RE: **#06ITB49977K-RS, Southwest Arts Center**

Addendum No.1

**SW Arts Phase II Performance Theatre**  
**ITB No. 06ITB 49977K-RS**  
**Addendum 1**  
**6/09/2006**

This Addendum forms a part of and modifies the bidding requirements and proposed Contract Documents for the subject Project, dated **May 8, 2006**. Receipt of this addendum shall be acknowledged on the Bid Form.

PROJECT NAME  
FULTON COUNTY  
SW ARTS  
PHASE II THEATER  
SHEET TITLE  
UTILITY PLAN

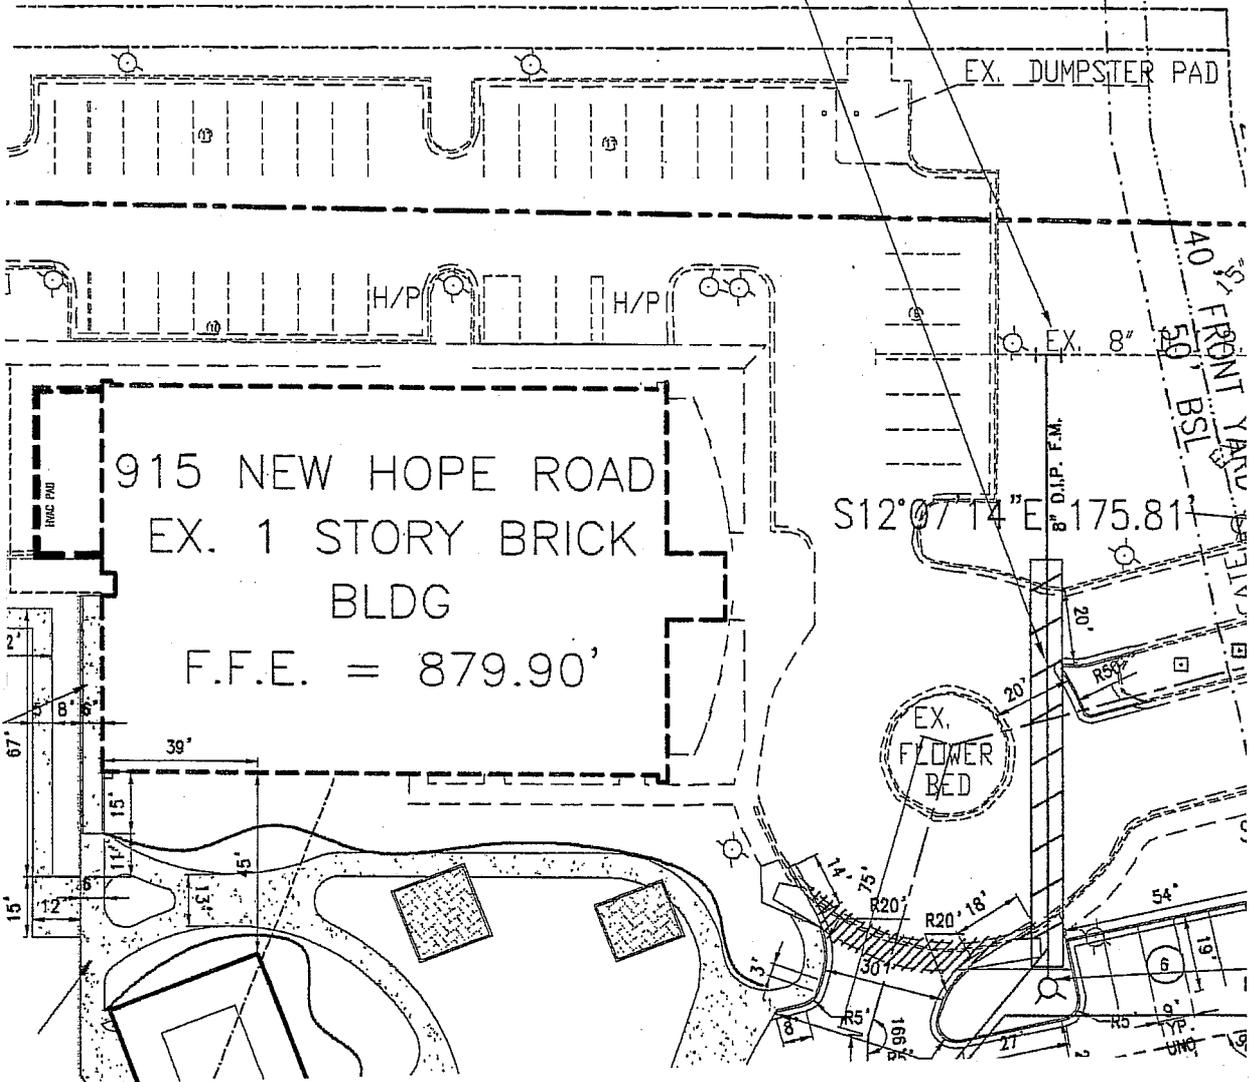
48. Issue SK-37:
- Revise drawing C1.2 to delete boring and allow asphalt cut, demo & patch.
49. Revise Specification Section 02 610 Asphalt Paving to delete gravel material cost from project; Contractor to haul from County-sourced free base stone and asphalt plant mix stone for asphalt paving scope provided; the asphalt sub will pick-up stone and deliver to jobsite from quarry

**CONTRACTOR'S OPTION:**  
DELETE BORING. CUT ASPHALT, DEMO,  
AND PATCH.

**1 ELEVATION @ PROSCENIUM**  
F6 1/4" = 1'-0"

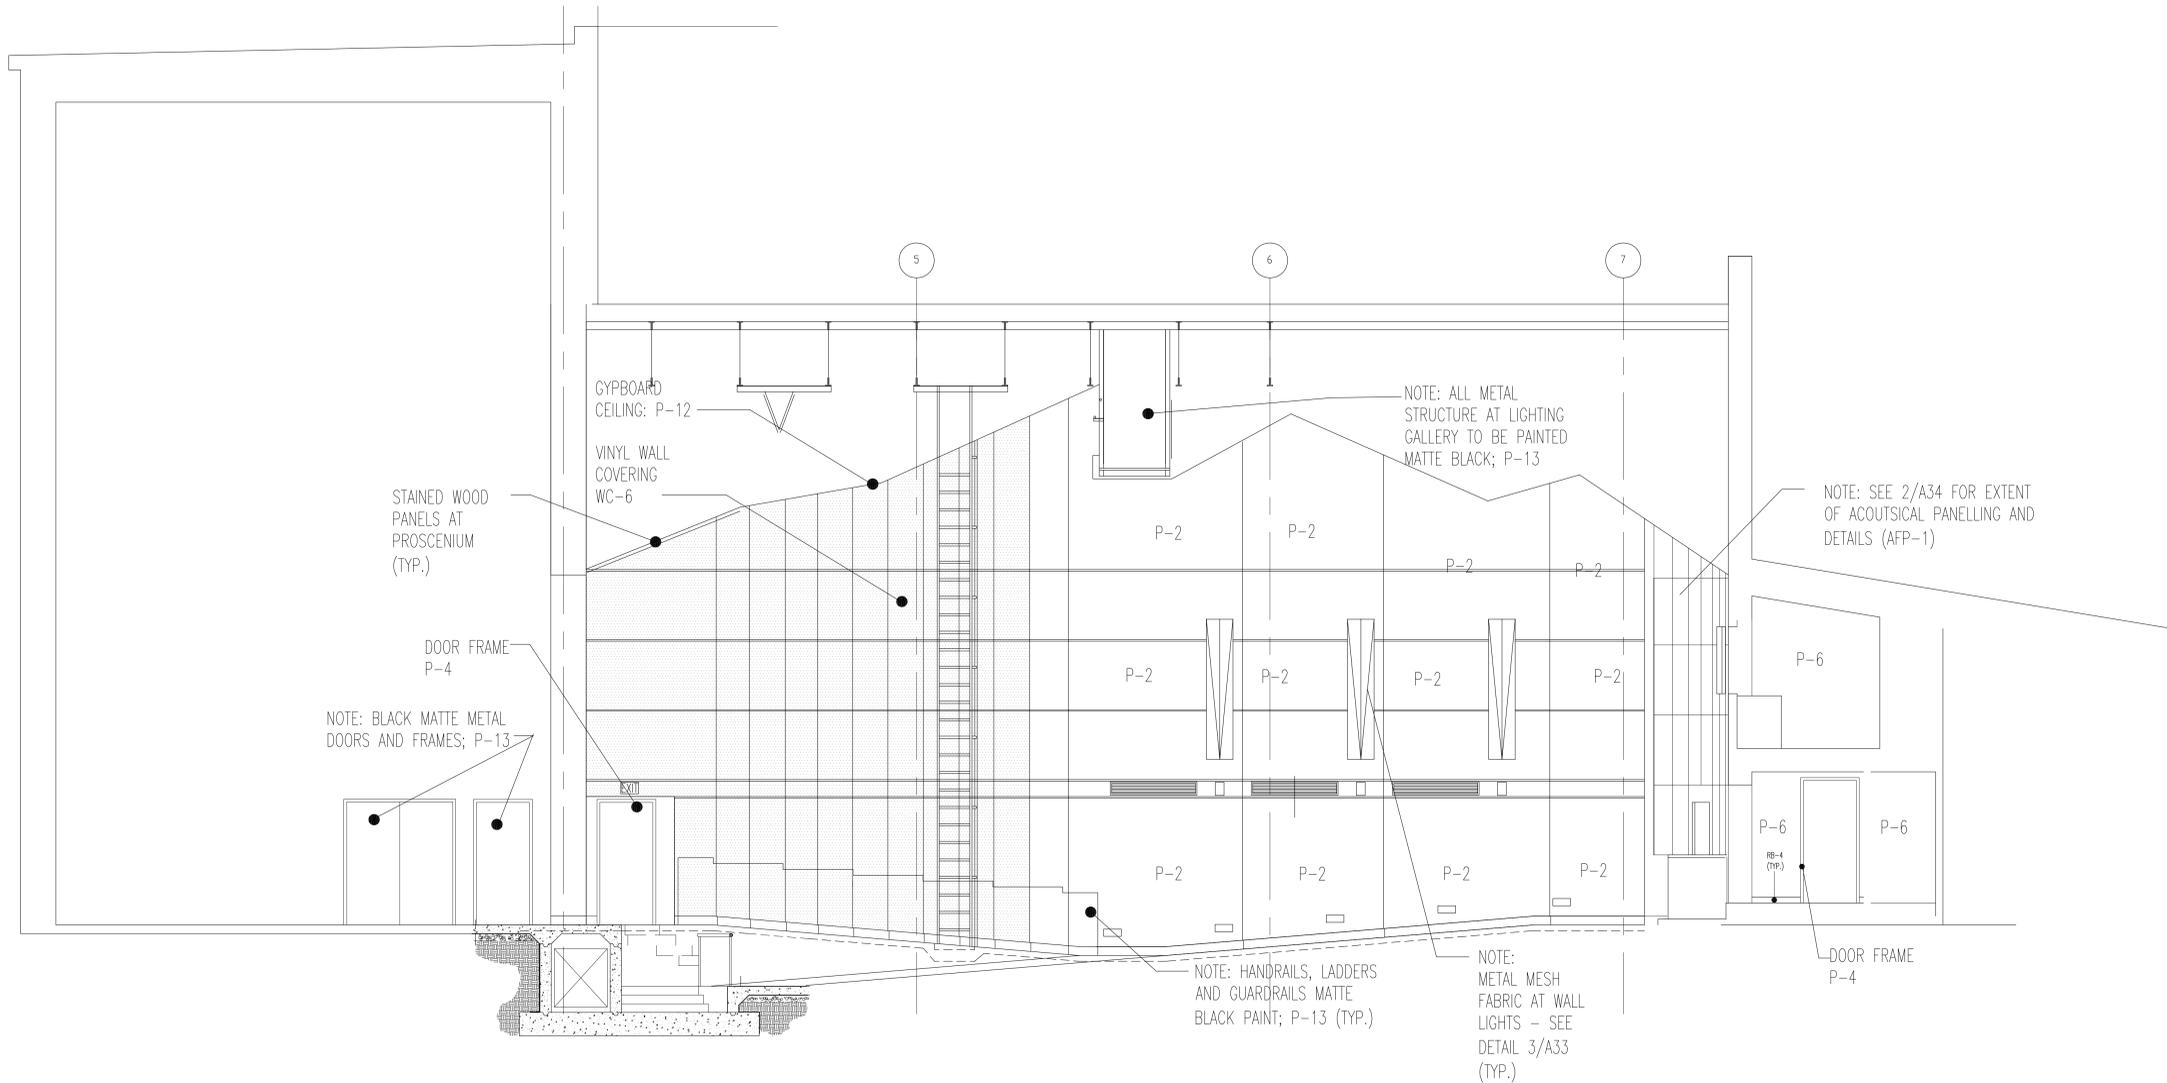
43. **Q:** Please clarify the mesh fabric shown on F6 is per architectural drawings.  
**A:** Issue Revised Sheet F6 to:
- Clarify mesh fabric at side walls of theater.

44. **Q:** Drawings F6 and F7 still indicate wood panels in the theater. Please clarify.  
**A:** Issue Revised Sheets F6 & F7 to:
- Clarify extent of wood finishes on walls and coordinate with architectural drawings.
